SUBJECT: ISSUANCE OF AMENDMENT (TAC NO. 68360)

The Commission has issued the enclosed Amendment No. 139 to Facility Operating License No. DPR-65 for Millstone Nuclear Power Station, Unit No. 2, in response to your applications dated November 15, 1988 and February 1, 1989.

This amendment allows operation of Millstone Unit 2 for Cycle 10. The changes to the Technical Specifications reflect a revised safety analysis that includes the use of fuel designed and fabricated by Advanced Nuclear Fuels Corporation. Fuel designed and fabricated by ANF has not been previously utilized for Millstone Unit 2. The changes to the Technical Specifications also reflect the effects of reduced reactor coolant flow from 340,000 to 325,000 gpm.

Amendment No. 139
License No. DPR-65

FIGURE 2.1-1 REACTOR CORE THERMAL MARGIN SAFETY LIMIT - FOUR REACTOR COOLANT PUMPS OPERATING

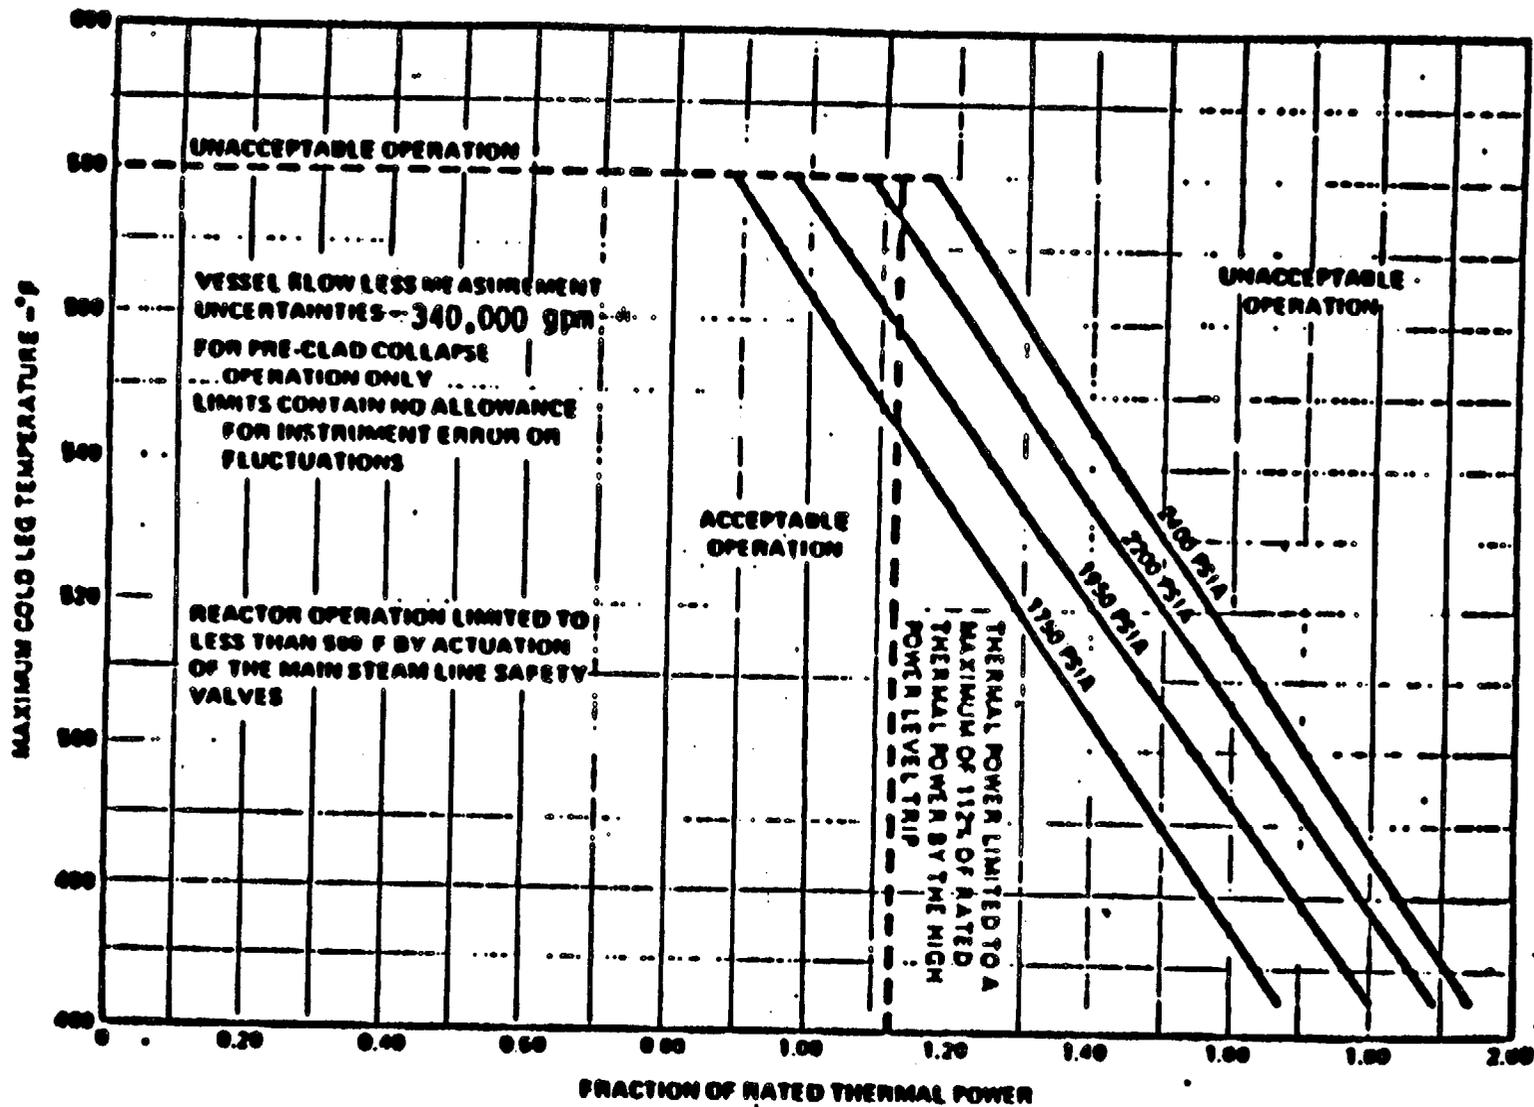
*Flow_T reductions, to 325,000 gpm are compensated for by reductions in the F_r limit (Specification 3.2.3)

2. Page 1-5 of the definitions - Deletes the definition for F_{xy} because F_{xy} is being removed from the Technical Specifications.
3. Section 2.1.1 (Figure 2-2 on page 2-2) - A footnote is added to specify the minimum reactor vessel flow of 325,000 gpm for the case with the reduced Fr as specified in Technical Specification 3.2.3. This change is consistent with the assumptions used in the acceptable analytical results (Ref. 30) and is acceptable.

FIGURE 3.2-2 AXIAL SHAPE INDEX vs. FRACTION OF ALLOWABLE POWER LEVEL

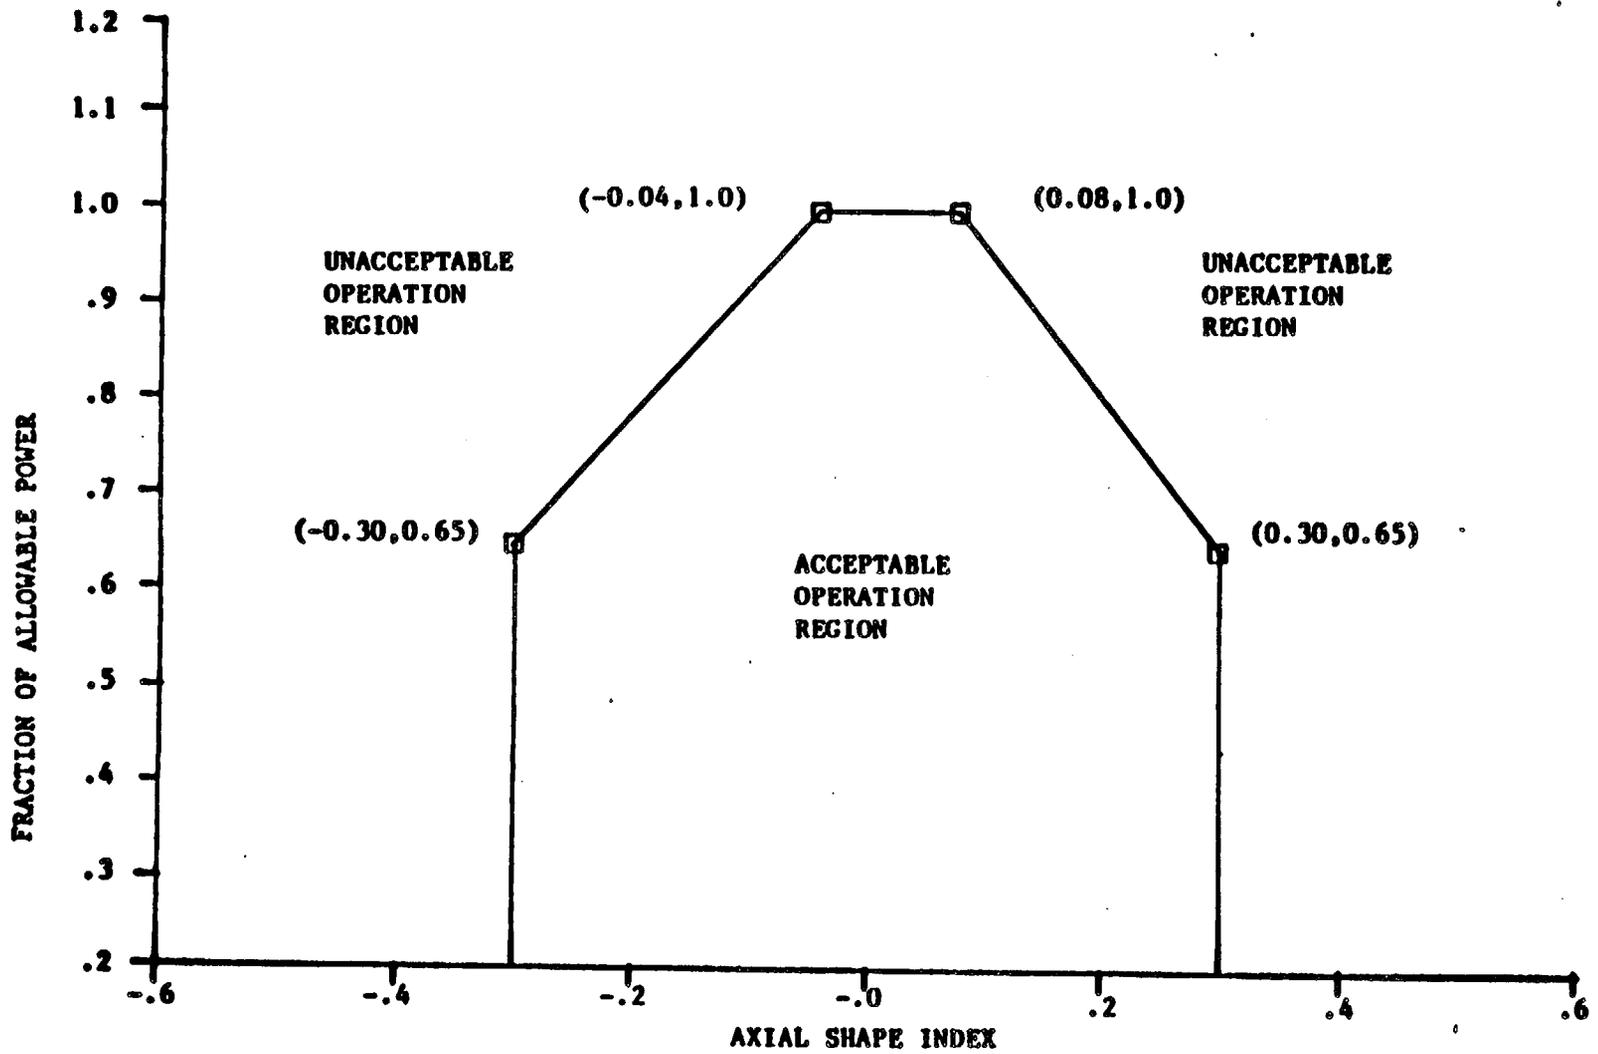
The LHR and the ASI requirements for monitoring of the LHR on Figure 3.2-2a are retained. Figure 3.2-2a is renumbered as 3.2-2 (Ref. 29). Figure 3.2-2b is deleted from the Technical Specification. The changes are consistent with the assumptions used for LOCA (Refs. 9 & 30) and set-point analyses and are acceptable.

- (ii) Item b of Section 3.2.1 is combined with the introductory sentence. References to the maximum allowable power limit are deleted as discussed in item (i) above. The two separate conditions following the "either" are separated as Items a and b. References to Technical Specification 3.2.2 are changed to refer to Figure 3.2-2 as discussed above.

- (iii) Section 4.2.1.2.b (page 3/4 2-2) - Reference to Technical Specification 3.2-2 is changed to Figure 3.2-2 as discussed above.
- (iv) Section 4.2.1.2 (page 3/4 2-2) - Deletes Item C which requires verification every 31 days of operation within the limits of Figure 3.2-2. Since the limits of figure of 3.2-2 are monitored continuously by the power ratio recorder per Technical Specification 3.2.1, we find that Item C is redundant to a more restrictive requirement and deletion of Item C is acceptable.

FIGURE 4.2.1 Augmentation Factor vs. Distance from Bottom of Core
(only applicable to fuel batches "A" through "L")

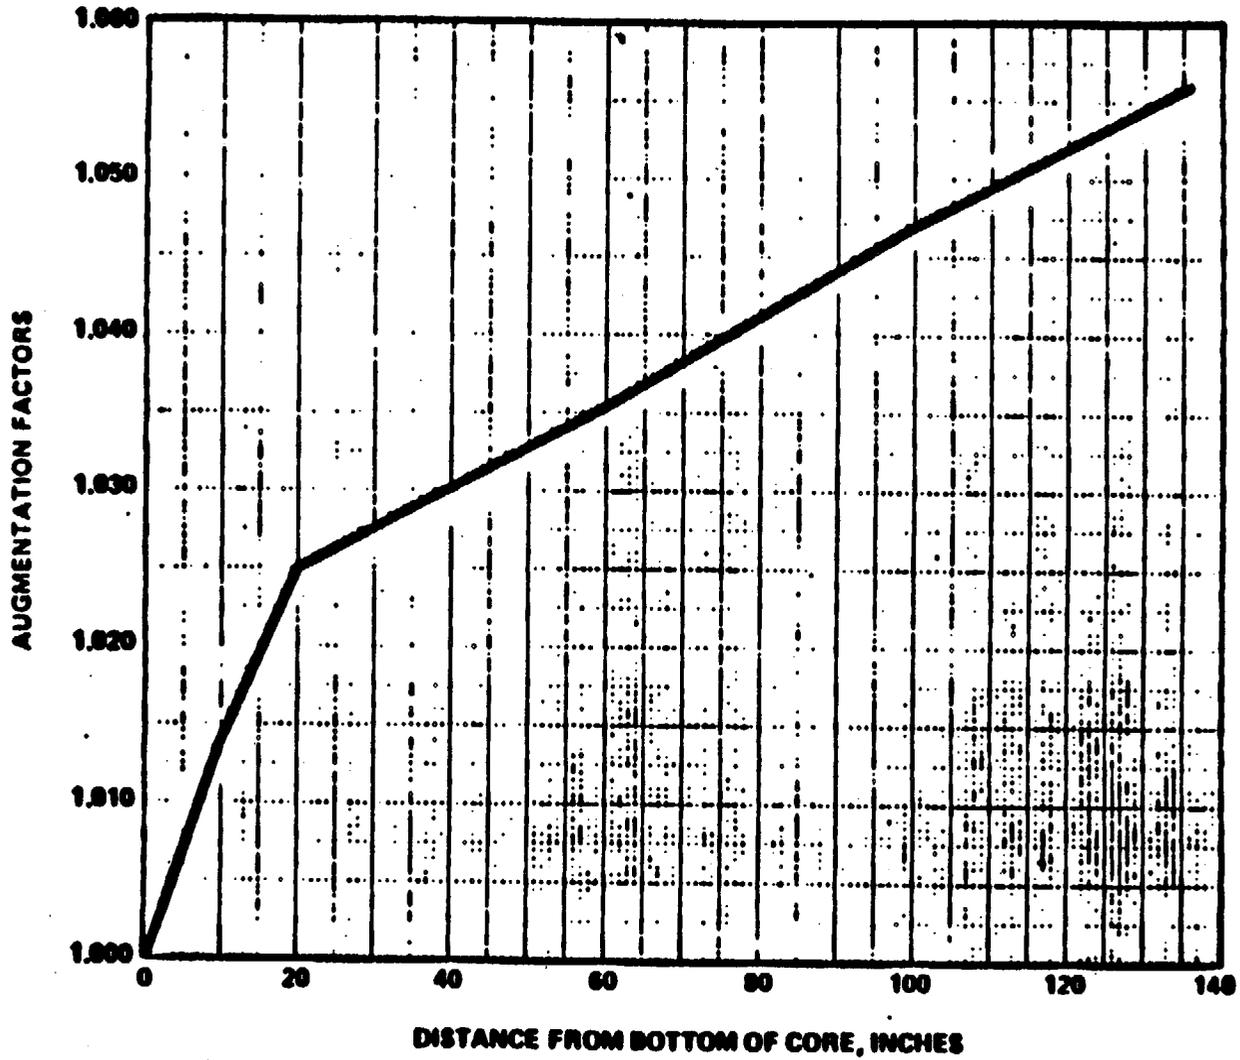
10. Section 4.2.1.3 (page 3/4 2-2) - Deletes two penalty factors. They are (1) Item 4.2.1.3.b.1, the flux peaking augmentation factor as shown in Figure 4.2-1 and (2) Item 4.2.1.3.b.4, the LHR uncertainty factor of 1.01 due to axial fuel densification and thermal expansion. Based on the following reasons, we find the deletions acceptable.

The removal of these penalties only applies to the ANF fuel. They should still be applied to the Westinghouse and Combustion Engineering fuel when used in the core. Therefore, footnote is applied to these two factors (Item 4.2.1.3.b.1 and 4.2.1.3.b.4 on page 3/4 2-2) specifying that they only apply to the non-ANF fuel. This footnote is also added to Figure 4.2-1 (page 3/4 2-4).
